This letter is in response to the three questions contained in your email of March 2, 2009 regarding "Application for Risk-Based Cleanup of Soil at Haley's Ditch" dated January 9, 2009. Your questions are highlighted in bold followed by Lockheed Martin's response.

Summary of Major Restoration Excavation and Remediation Grading Activities Related To The Streambed

Restored Channel Schematic

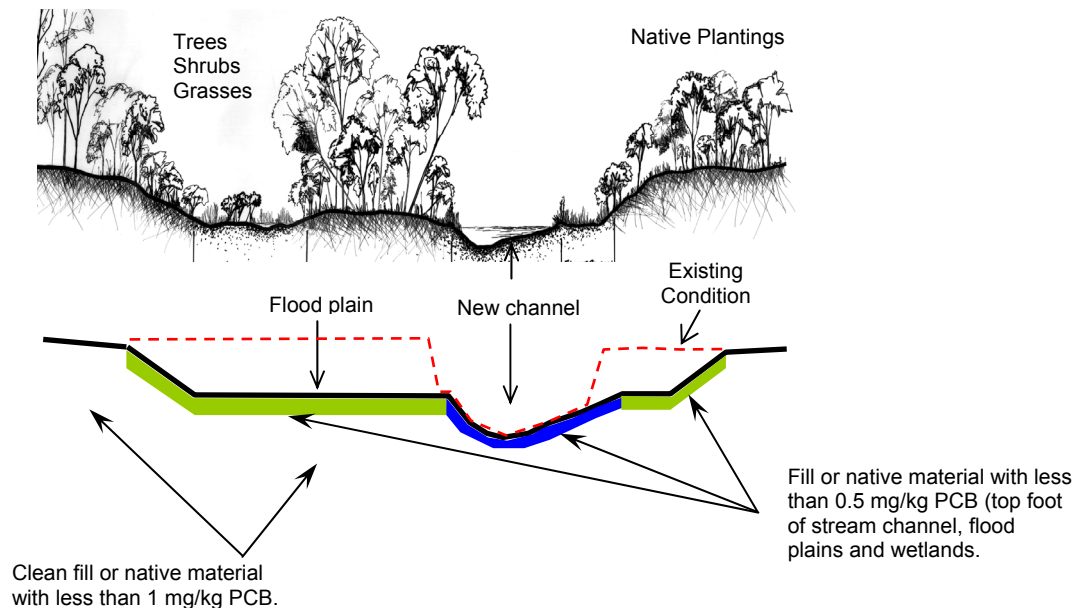
1) Clean Fill PCB Concentrations: It is stated in the Executive Summary (page i) and in Section 2 that "The excavation areas, except the stream channel and wetlands, will be backfilled, as needed, with soil containing less than 1 mg/kg total PCBs. The restored stream channel and wetland areas will be covered with clean fill material containing less than 0.5 mg/kg PCBs." The soil cleanup action level is 1 mg/kg whereas the cleanup action level is less than 0.5 mg/kg PCBs for Haley's Ditch sediment. Setting the cleanup action levels and the clean fill material levels to the same values does not provide adequate "buffer" to account for sampling uncertainties and to ensure recontamination does not occur. Dave mentioned the possibility of reusing some of the fill material removed as part of the remediation activities instead of having to bring in all new fill. Ohio EPA cautions against reusing PCB contaminated fill material from the site due to sampling uncertainties and the potential for recontaminating remediated areas. It is recommended that imported clean fill, which has been tested to be generally nondetect for PCBs, be used for restoration activities.

2) Stream Bed Fill Material: It should be clarified in the document that the stream bed fill material will primarily consist of a mixture of sand, gravel, cobble and other similar materials to prevent significant erosion and siltation from occurring downstream. Otherwise, a large rain event could readily wash other types of fill materials downstream.

- The cleanup standard for this project is 1 mg/kg total PCB.
- Remove all soft sediments from the streambed.
- Collect verification samples from the soil remaining after the streambed sediments are removed and continue to excavate until results are less than 1 mg/kg.

- Create a sub-grade for the stream channel and potentially wetted areas by relocating soils with less than 1 mg/kg total PCB within the project area, or importing soils with less than 1 mg/kg total PCB, as needed.

- Create a final grade in the stream channel with a one-foot thick top layer of sand, gravel, stone and other appropriate materials for erosion control having a total PCB concentration of 0.5 mg/kg or less.

- Create a final grade in potentially wetted areas including the flood plain areas and wetlands with a one-foot thick top layer of soil or other materials as appropriate having a total PCB concentration of 0.5 mg/kg or less.

The restored stream channel will be designed as a natural meandering channel with riffle-pool complexes. The final grade will be restored using imported glacial till from a local sand and gravel quarry containing a heterogeneous mixture of sand gravel and cobble to prevent erosion.
